RFP 2016-0009 - ADDENDUM 2

COLIGNY REDEVELOPMENT PROJECT

Town of Hilton Head Island, South Carolina

Date Issued: July 29, 2016

2 FP0.001 FIRE CONNECTION PIPING SCHEMATIC
NOT TO SCALE

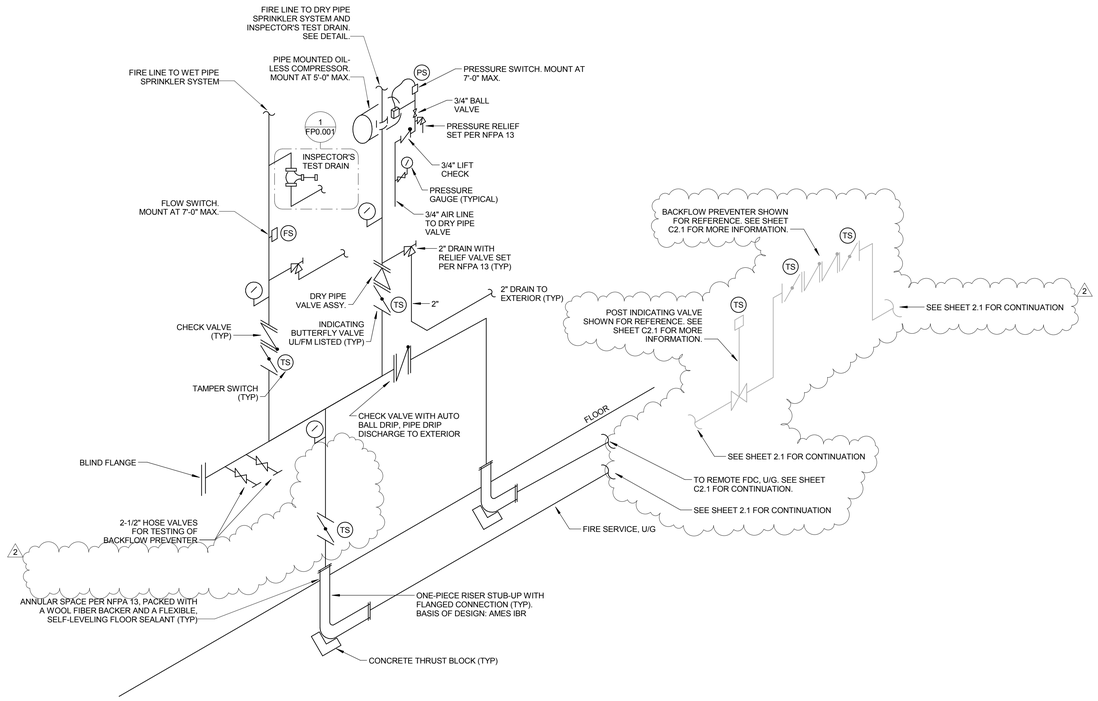
A. Updated General Fire Protection Note 20 regarding sprinkler piping options.
B. Clarified location of backflow preventer, and revised Fire Connection Piping Schematic 2.

4 E0.001 HANDHOLE DETAIL
NOT TO SCALE

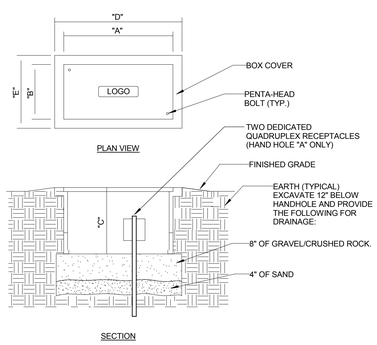
A. Updated Hand Hole detail.
B. Added site power general note.

5 E0.002 LIGHT POLE MOUNT DETAIL
NOT TO SCALE

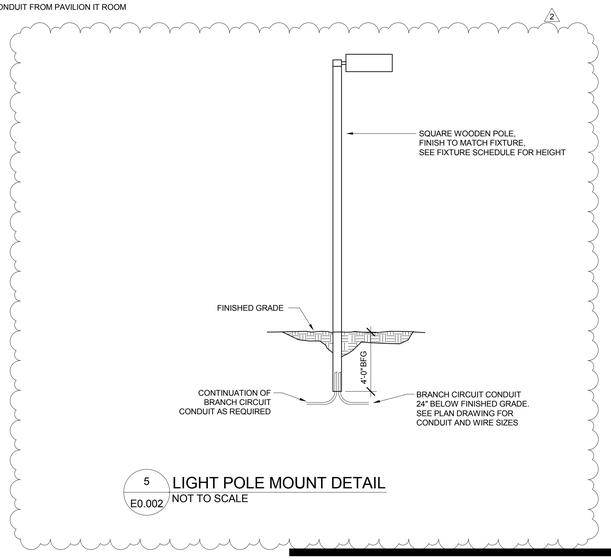
A. Updated site shoe box fixture part number and pole part number
B. Added light pole mounting detail

2 / E0.010 CHILDREN'S MUSEUM ONE-LINE DIAGRAM
NOT TO SCALE

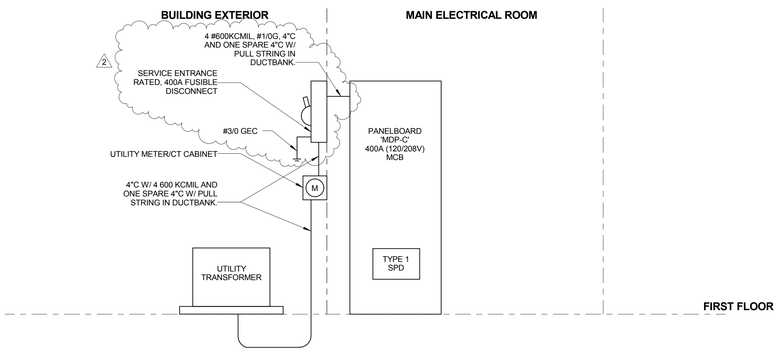
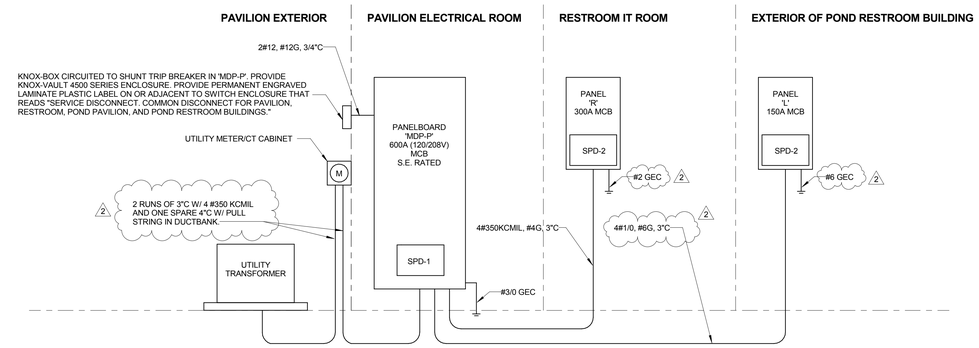
A. Adjusted conductor and disconnect details for Children's Museum one-line diagram
B. Adjusted conductors for Pavilion/Restroom one-line diagram.
C. Added surge protection device schedule

1 E0.060 ELECTRICAL SITE PLAN - PAVILLION
SCALE: 1" = 20'-0"

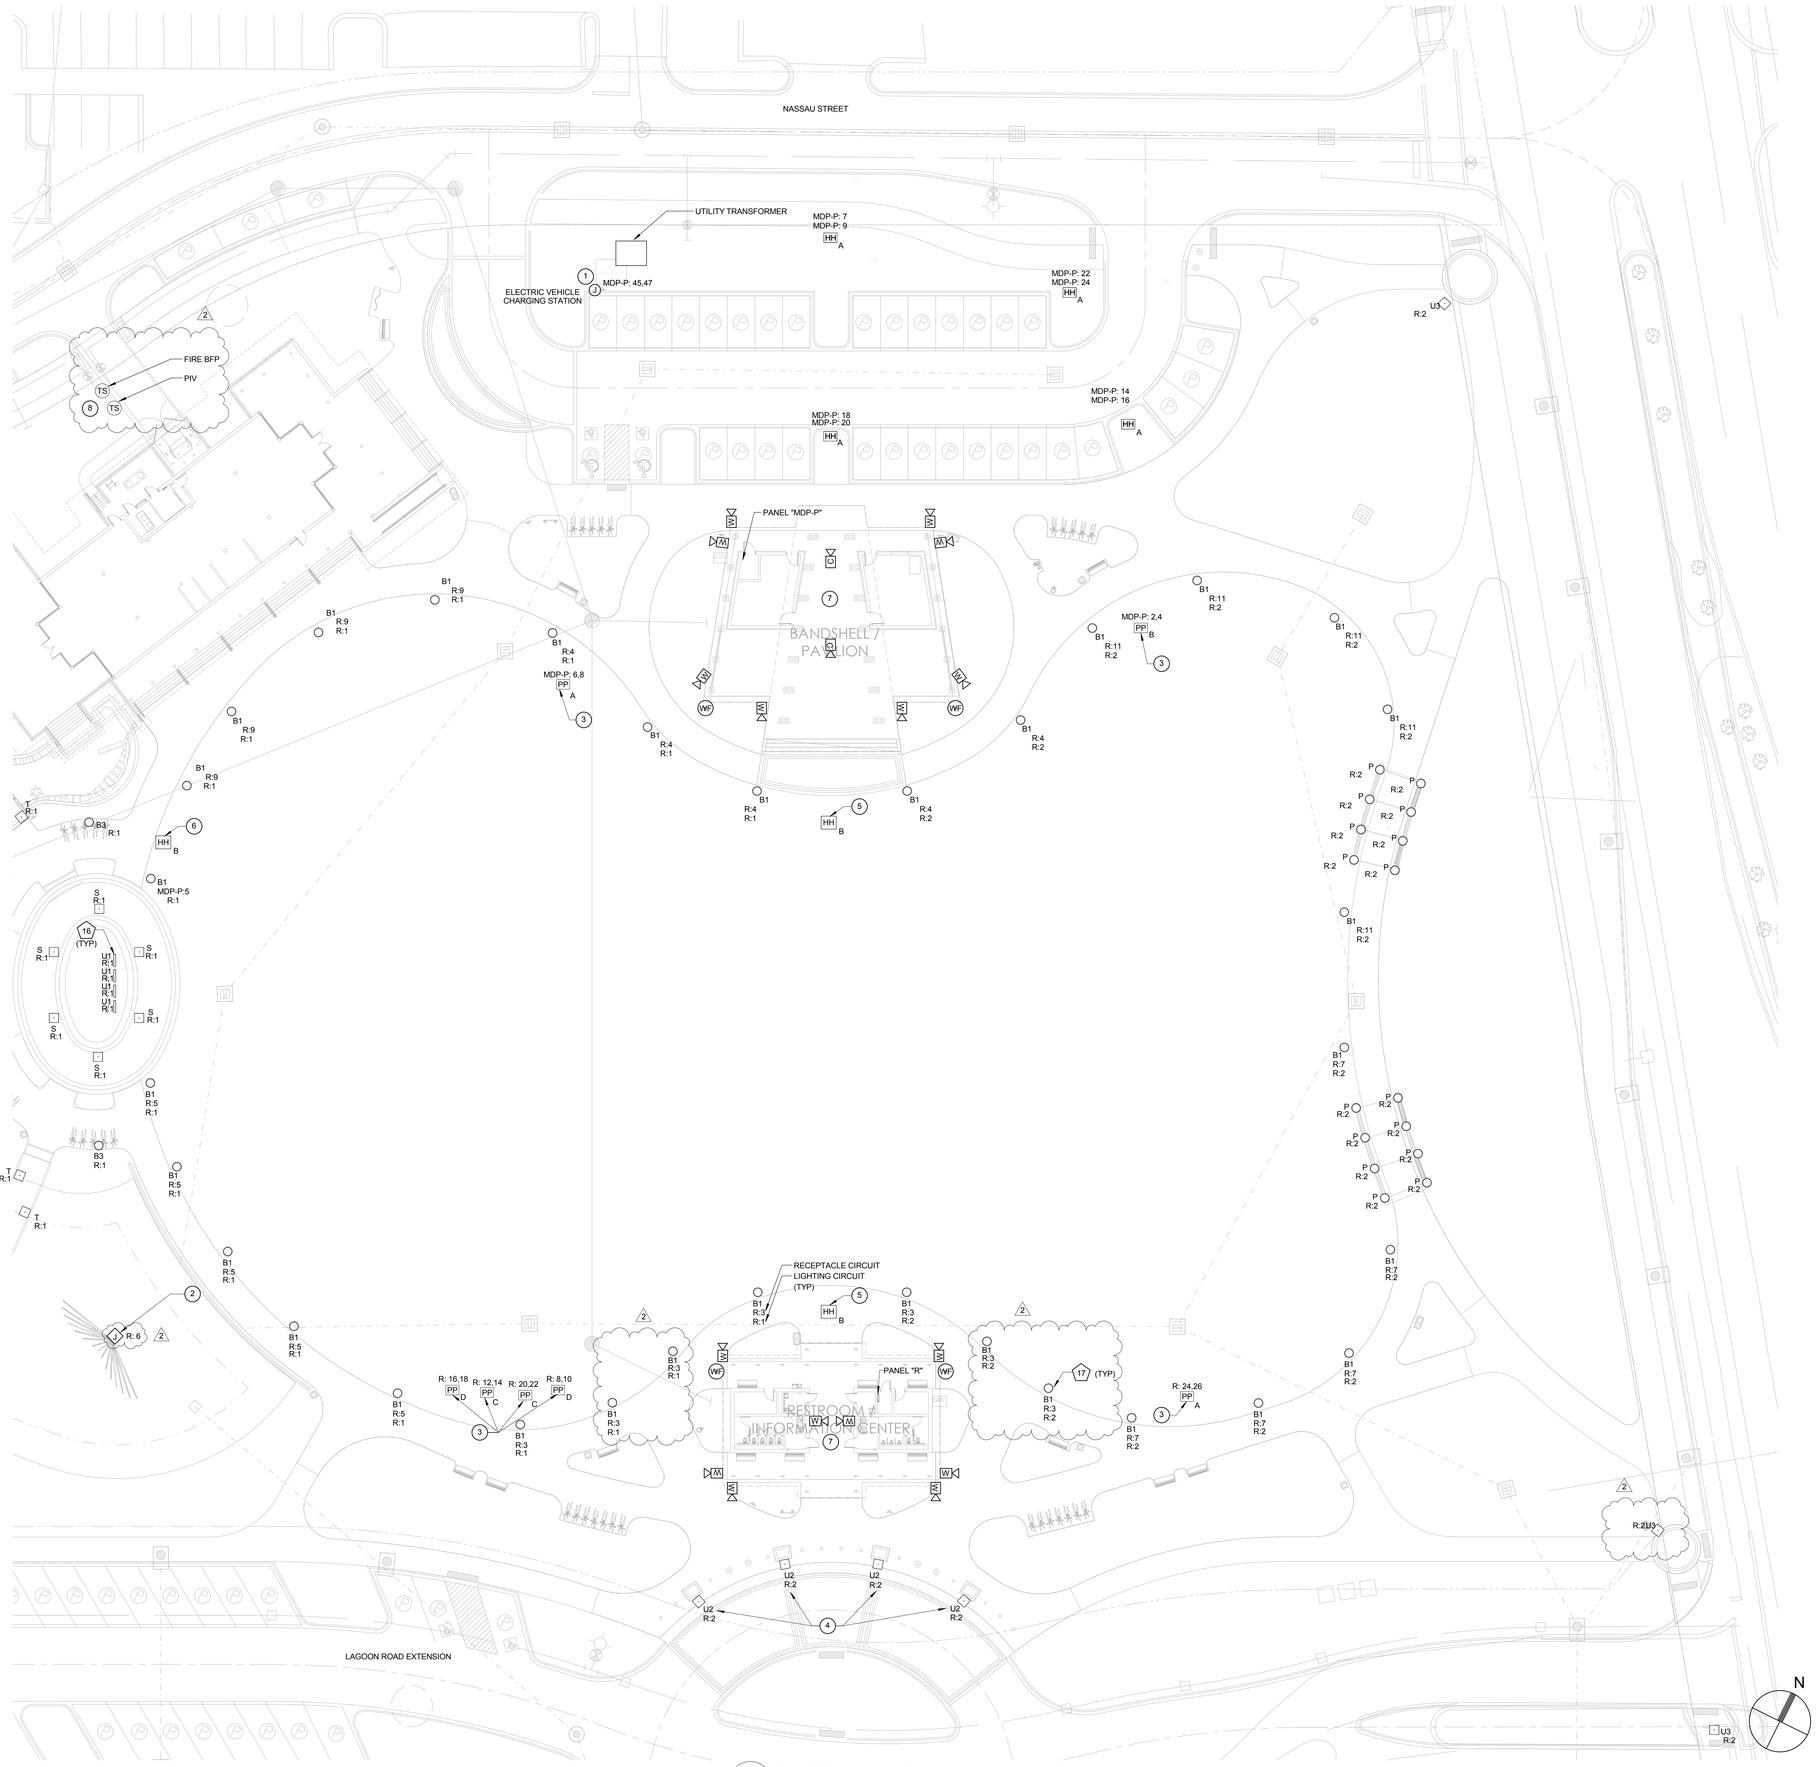
3.18 E0.060 – ELECTRICAL SITE PLAN PAVILION

A. Bollards moved/added near Restroom/Information Center
B. Sign uplight added East of Restroom/Information Center
C. Added tamper switches for Fire backflow preventer and post indicator valve

1 E0.061 ELECTRICAL SITE PLAN - PARK
SCALE: 1" = 20'-0"

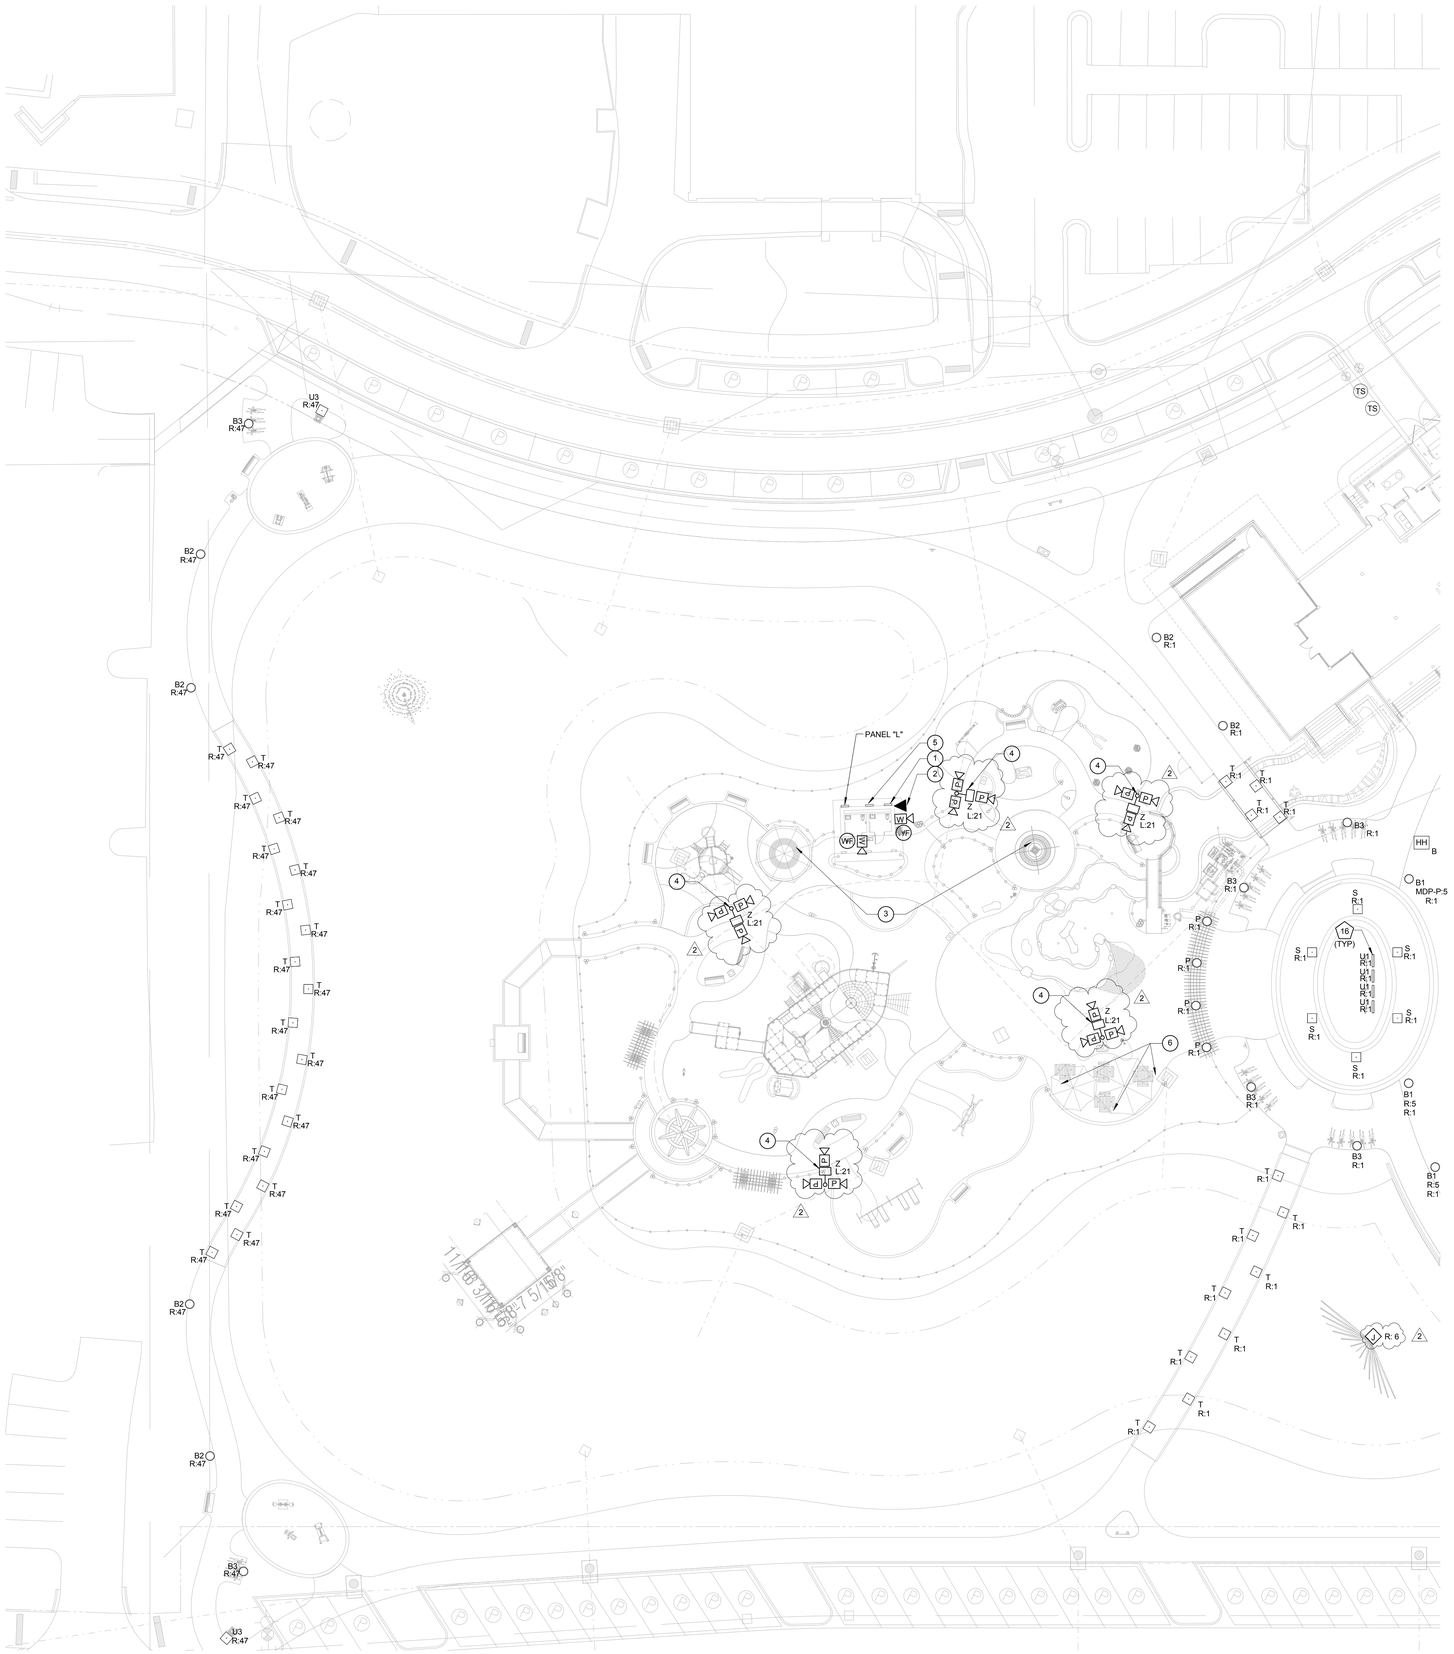
3.19 E0.061 – ELECTRICAL SITE PLAN PARK

A. Security light poles added around park area.

1 / E1.103 CHILDRENS MUSEUM SYSTEMS PLAN
SCALE: 1/8" = 1'-0"

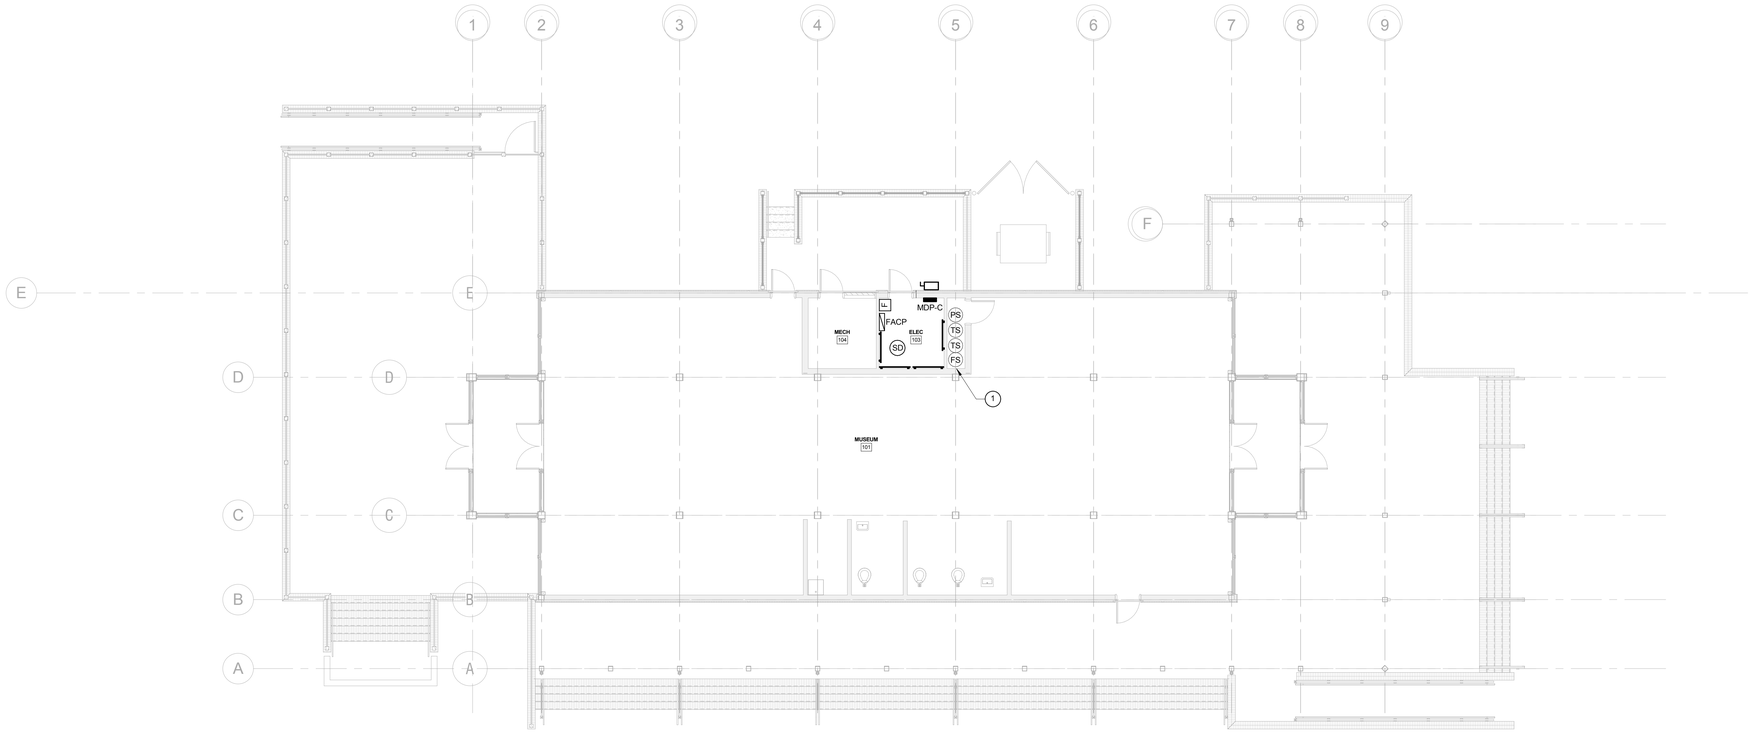
3.20 E1.103 – CHILDRENS MUSEUM SYSTEMS PLAN

A. Note added referencing tamper switches added shown on site plan

1 / E2.101 PAVILION POWER & TELECOM. PLAN
SCALE: 1/4" = 1'-0"

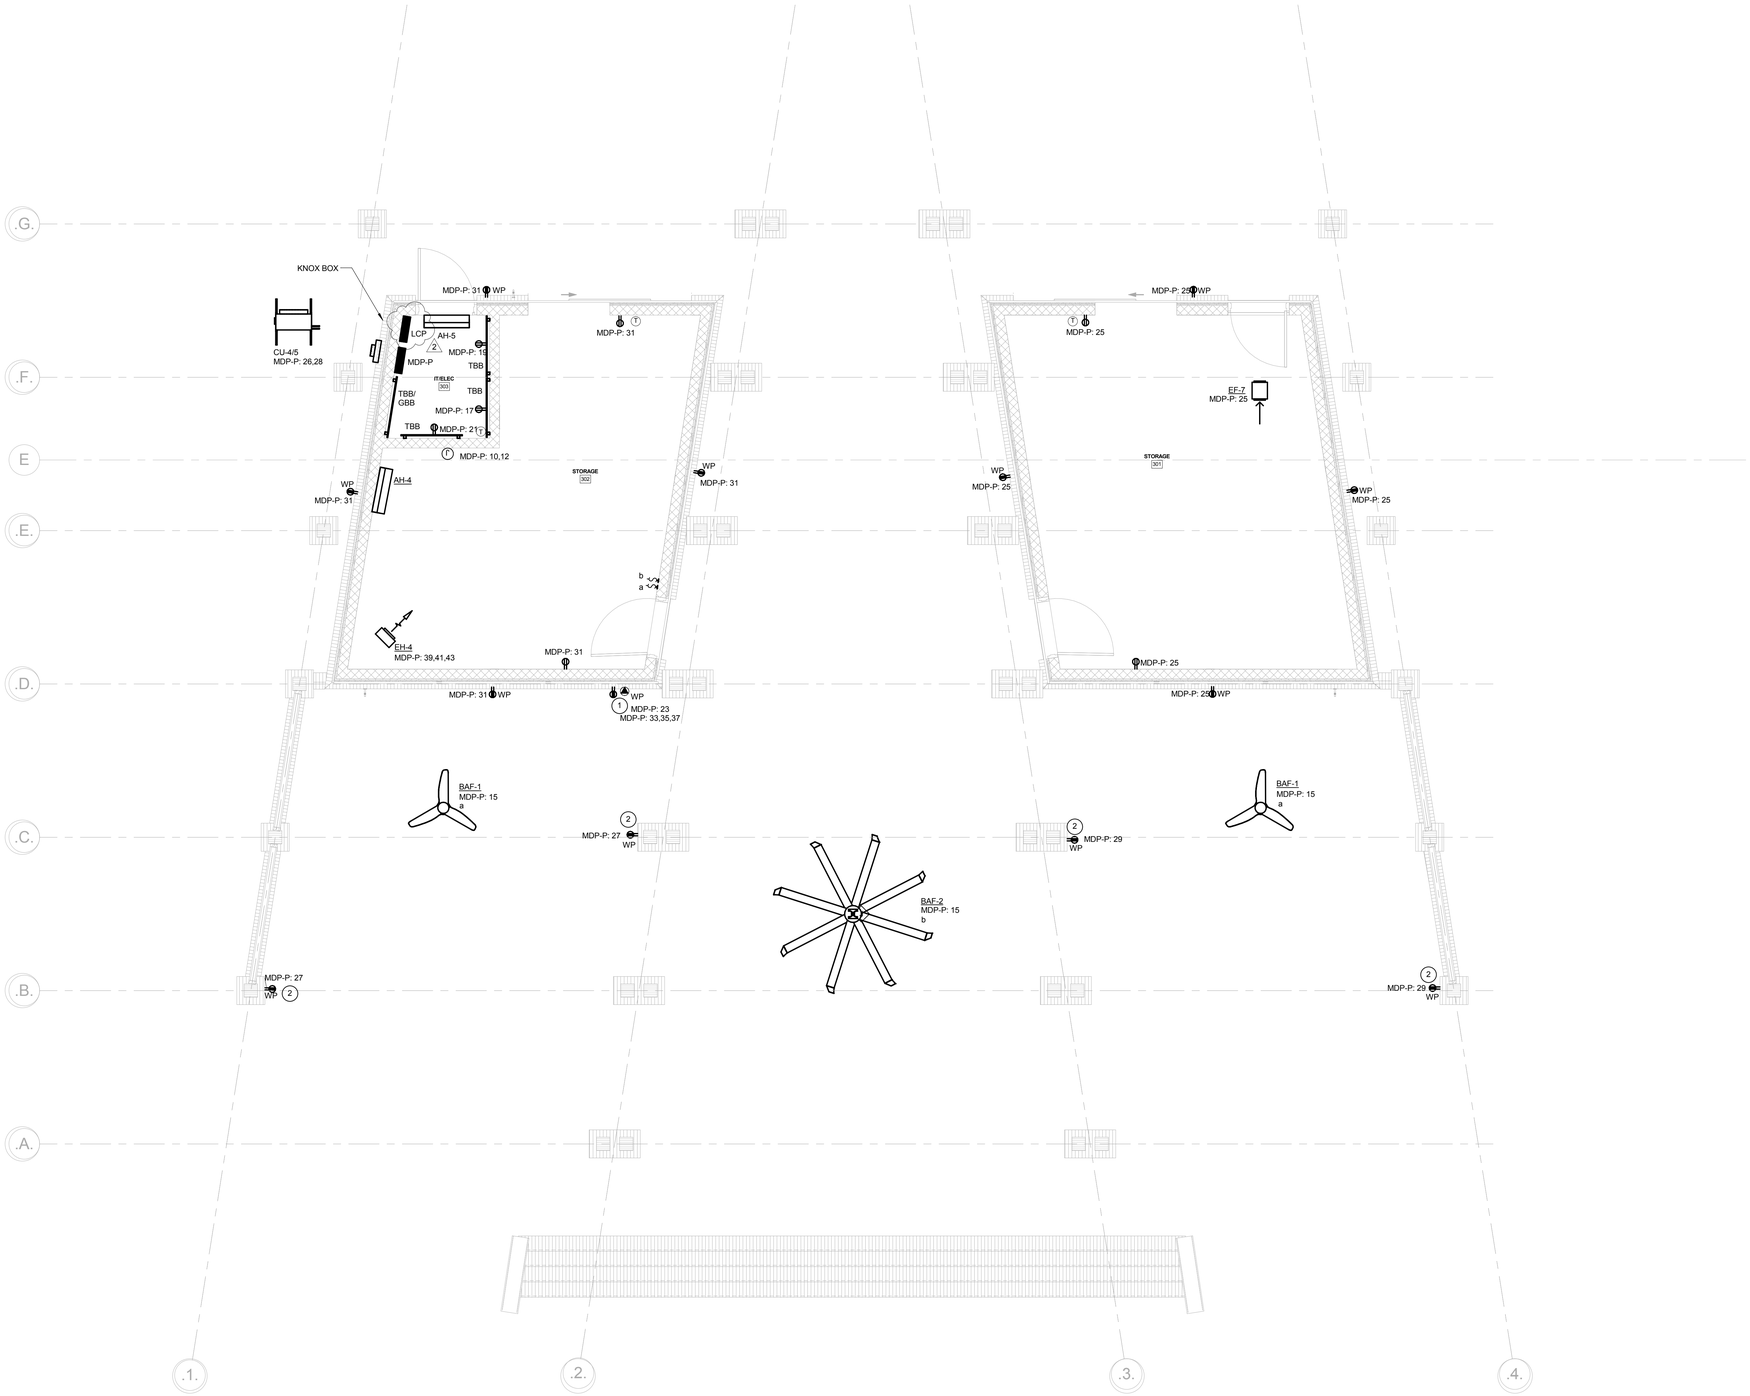
3.21 E2.101 – PAVILION POWER & TELECOM. PLAN

A. Lighting Control Panel added
